Access Compliance Report

Public Rights-of-Way

(Curb Ramps)

Intersection ID: 12413	Main Street: N_BREVARD_ST	Cross Street: E_6TH_ST	Location:	N
ADA ID: AC3A8868FE6C	Ramp Type: Perp	Initial Pass/Fail: Fail	Overall Compliance: No	Severity Score: 12.5
Codes/Mitigation Info/Possible Solution		Field Measurements/Component Compliance

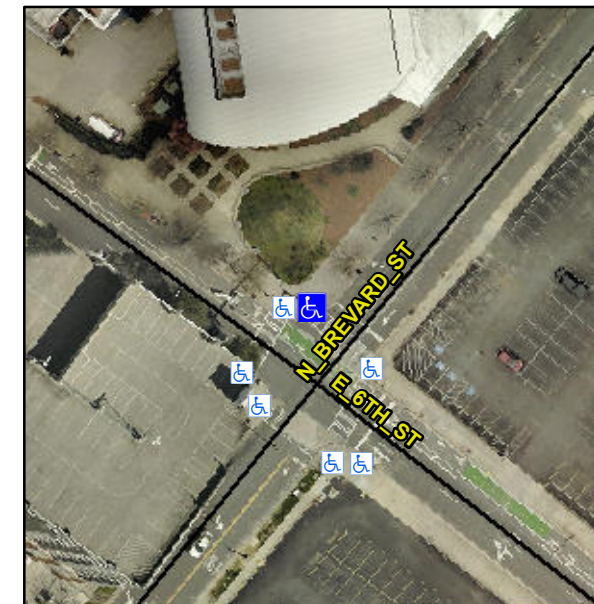
Not Found, R304.2.2

Compliance	Description	Data	Compliance	Description	Data
N/A	Ramp Length (in)	72.0	No	Ramp Slope (%)	9.8
Yes	Ramp Width (in)	48.0	Yes	Ramp XSlope (%)	0.7
N/A	Flare Type LT	N/A	N/A	Flare Type RT	N/A
N/A	Flare Slope LT (%)	N/A	N/A	Flare Slope RT (%)	N/A
N/A	Flare Traversable LT?	N/A	N/A	Flare Traversable RT?	N/A
N/A	Landing Length (in)	N/A	N/A	DWS Provided?	N/A
N/A	Landing Width (in)	N/A	N/A	DWS Contrast?	N/A
N/A	Landing Slope (%)	N/A	N/A	DWS Length (in)	N/A
N/A	Landing X Slope (%)	N/A	N/A	DWS Full Width?	N/A
N/A	Landing Curb? (Y/N)	N/A	N/A	DWS Offset (in)	N/A
N/A	Shared Landing?	N/A			
N/A	Gutter Ponding?	N/A	N/A	Gutter Slope (%)	N/A
N/A	Gutter Lip Ht (in)	N/A	N/A	Gutter X Slope (%)	N/A
N/A	Painted X Walk1?	Yes	N/A	Painted X Walk2?	N/A
	X Walk 1 Direction	To SE		X Walk 2 Direction	N/A
N/A	X Walk 1 Width (in)	112.0	N/A	X Walk 2 Width (in)	N/A
	X Walk 1 Slope (%)	0.6		X Walk 2 Slope (%)	N/A
	X Walk 1 X Slope (%)	0.2		X Walk 2 X Slope (%)	N/A

Remove & Replace Entire Ramp.
